Drawing Title
ADDENDUM 1

Project Title
**INSTALL FIRE WALL AND
CONFERENCE ROOM**

Location
**VA SERVICE AND DISTRIBUTION CENTER
HINES, ILLINOIS 60141**

DRAWING NO.
ASK-1

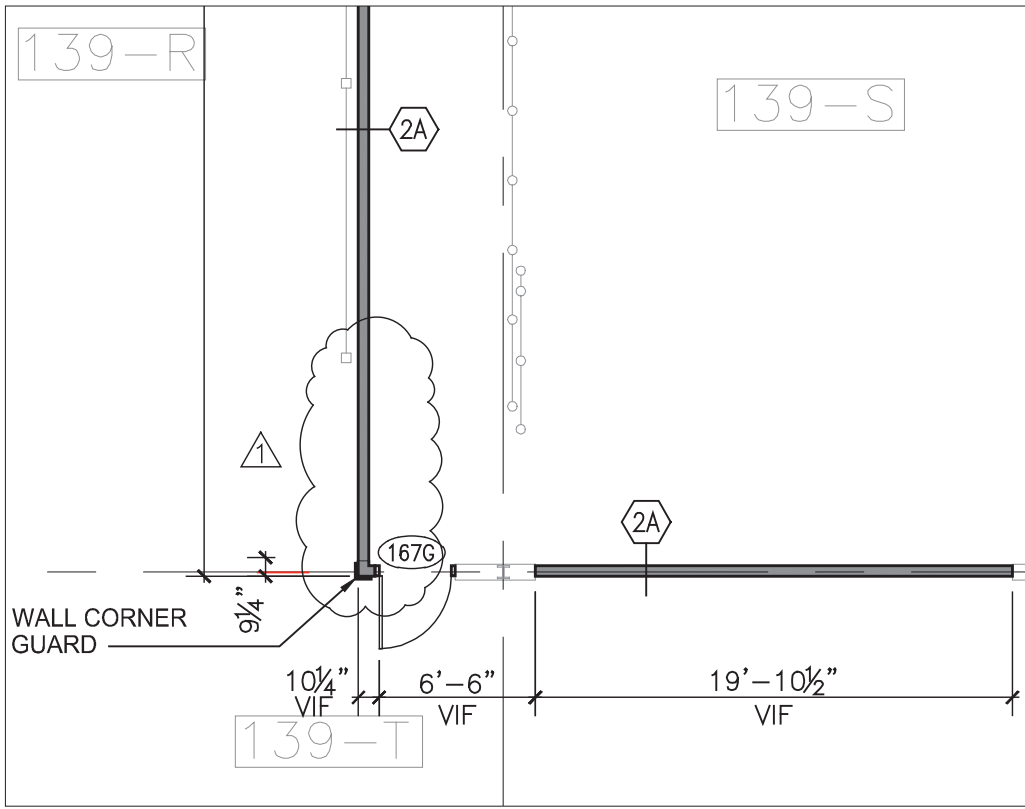
Referenced Drawings
Floor Plan (North), RCP (North), Door Schedule

Referenced Sheets
A1, A2, A3

NOTE 1: RELOCATE EXISTING DOOR HARDWARE AND CARD READER ACCESS SYSTEMS TO NEW DOOR AND FRAME.
